From: John Weis <johnweis32@comcast.net>
Sent: Wednesday, September 28, 2022 10:51 AM
To: Town Council <mayorandcouncil@townofchapelhill.org>; Pam Hemminger <phemminger@townofchapelhill.org>
Cc: Susan Lyons <ldilyons@gmail.com>; Scott Levitan <levitan@rtp.org>; Megan Patnaik <megan@ellencassillyarchitect.com>; Edward Hoskins <ted@edwardhoskins-aia-architect.com>; Colleen Willger <cwillger@townofchapelhill.org>; Corey Liles <cliles@townofchapelhill.org>; Adam Nicholson <anicholson2@townofchapelhill.org>
Subject: CDC Position on 710 Estes

CDC Summary of Comments re: 710 N Estes

September 6, 2022

Figure 4: North-South site section showing topography and unit stepping.

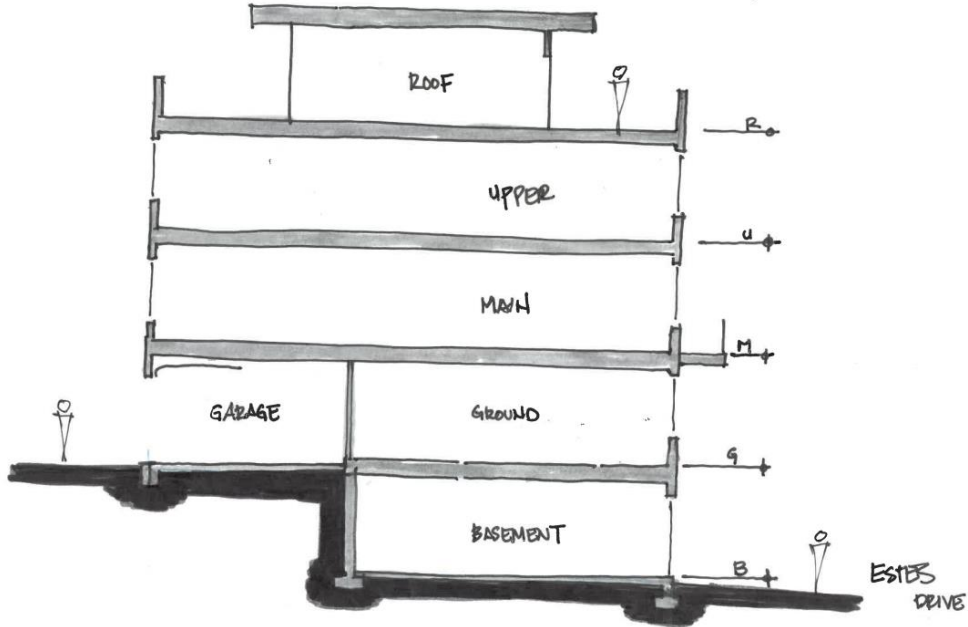
1. **Site design.** The proposed development is not well integrated with the existing topography. There is massive clear-cutting, and a 15' tall, public-fronting retaining wall will leave a table top effect. The design doesn't emphasize the pedestrian realm. Rather, it is the circulation of vehicles (cars, fire trucks, garbage trucks) that is dictating the site organization – not the shaping of outdoor spaces or the community experience. We also believe there is too much parking for a town that is emphasizing multi-modal transit and this close to a transit station at the corner of Estes and MLK.

- Townhomes in this location should allow the topography to inspire the architecture. This could break up the elevation and bring positive visual appeal to the site. See concept below image.
The existing topography has been studied thoroughly and additional efforts to match it more closely are in progress. Proposed townhomes already step up to 6' along certain rows. Steeper slopes will eliminate ADA accessibility within the community, which is required.

The renderings were inaccurate and did not accurately depict the way the buildings are stepped between each townhome to work with the topography. This is now correctly rendered. Additionally, the building along Estes has been redesigned with a split-level foundation to work with the slope and eliminate the table topping effect. These units now better interact with the proposed path and a ramp was added to bike from the site directly onto the path. The retaining wall in question is not public-fronting except for the corner (about 50') however it now terminates down to 0' height. It is screened heavily by the permanently protected stream buffer. Most of the wall along Aura is approximately 6-7' tall. Town staff had asked for more visitor parking after the 1st CZP submission. Since the CDC meeting, we have reduced the number of 2-car parking garages and eliminated 40 spaces. The parking count is 205 reserved spaces for 95 units (a 2.1 ratio) and 20 guest parking spaces. We are open to reducing the guest parking count if required, although we think the current count is appropriate. We have committed to 23 (or more) biking spaces, exceeding the requirement by a multiple of 5.
